<b>Subject:</b>  HARD TO SHIFT INTO 3RD GEAR	<b>Bulletin No:</b> 05-008/14
	<b>Last Issued:</b> 07/14/2014

2012-2013 Mazda3 (SKYACTIV 6 M/T)

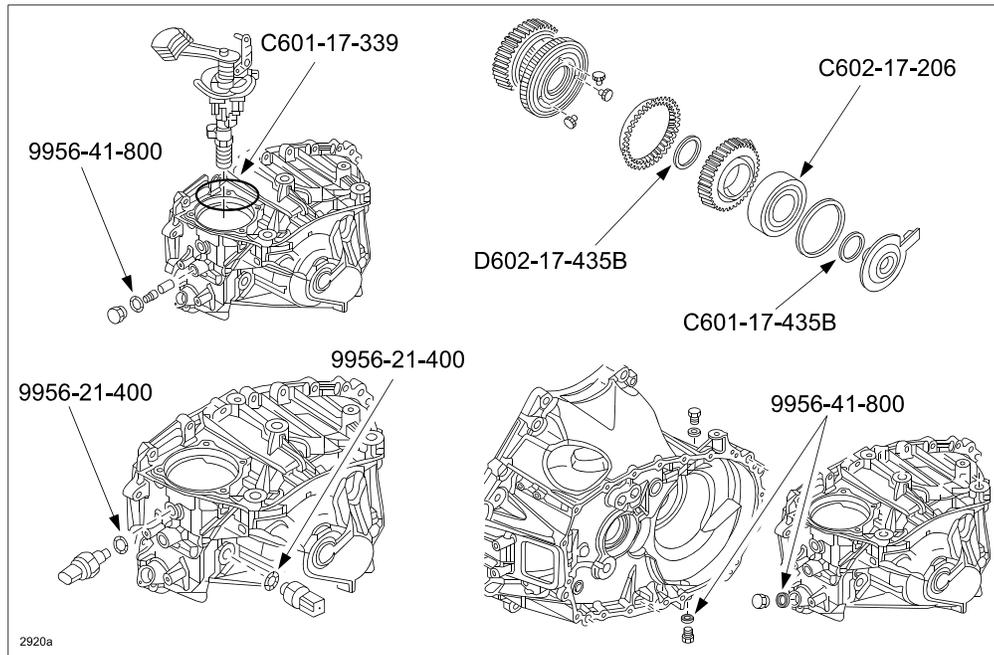
This is caused by the friction coefficient between the 3/4 clutch hub and the sleeve increasing. A surface treatment has now been added to the 3/4 clutch hub to decrease the friction coefficient.

1. Verify customer concern.
2. Remove the transaxle. Refer to MS3 online instructions or the Workshop Manual section 05-15.
3. Replace the 3/4 clutch hub with a modified one and the 3rd gear with a new one (listed in the Parts Information). Refer to the C66M-R 6-speed SKYACTIV Manual Transaxle Workshop Manual.
